MEMORANDUM – COASTAL ENGINEERING REVIEW PAIS – DOWN ISLAND CABIN CONSTRUCTION TAR 19802

21 April 2021

Figure 1: Location of Existing Cabin and Proposed New Cabin (NPS 2021)

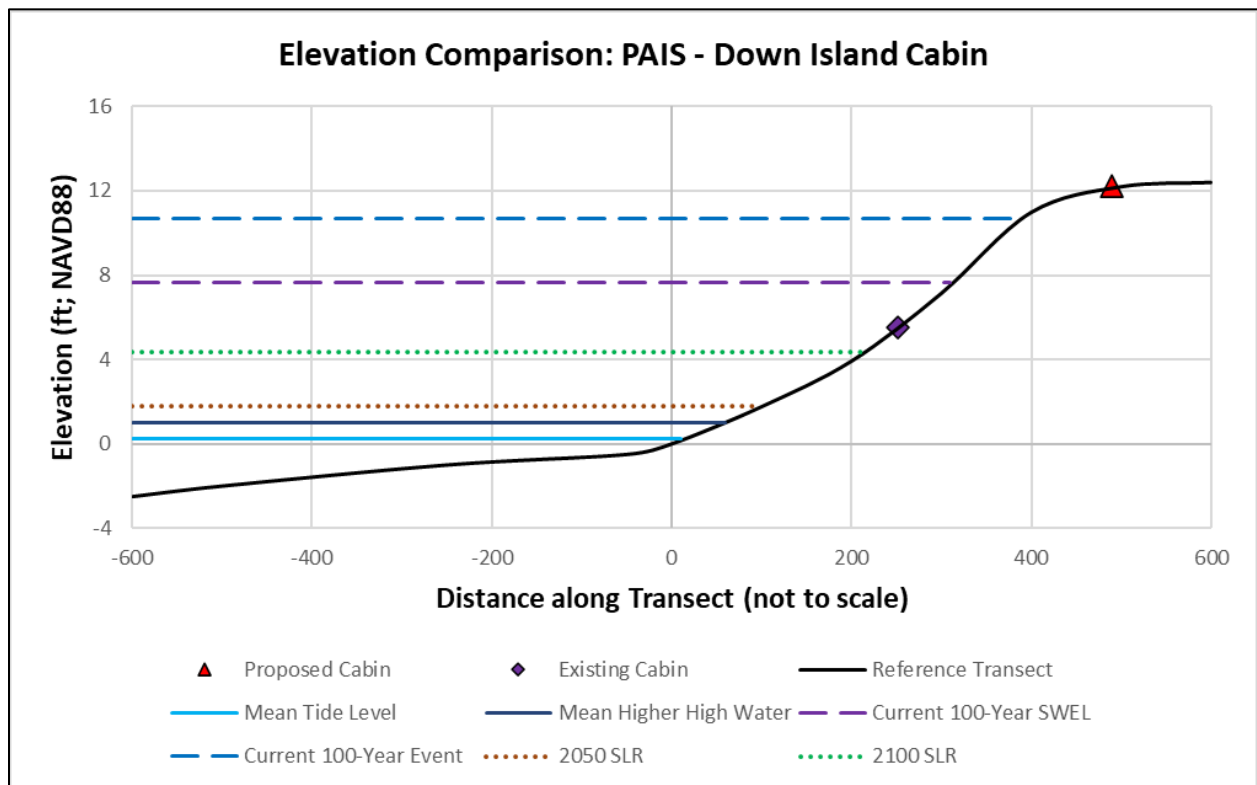
Siting the proposed cabin behind the initial dune line will help protect the structure from direct wave exposure, which has likely accelerated the existing cabin’s deterioration. Photographs reviewed during the conference call with PAIS site staff showed conditions after Hurricane Hanna, which resulted in substantial deposition of debris and sand beneath and around the existing cabin even though the existing cabin was built above grade. The proposed location moves the cabin outside the current 100-year flood elevation, with the additional 6-foot clearance provided by the pile foundation providing sufficient resiliency for projected SLR to the year 2050 combined with increased storm intensity. Reviewing elevation data near the proposed location reveals a 1- to 3- foot grade which could complicate construction. Dune lines are traditionally migratory features, and the dune may migrate towards the mainland during the design life of the structure. Localized heavy erosion events, such as seen during Hurricane Hanna, can cause significant shifting of the dune features and may erode material around the proposed pile supports.
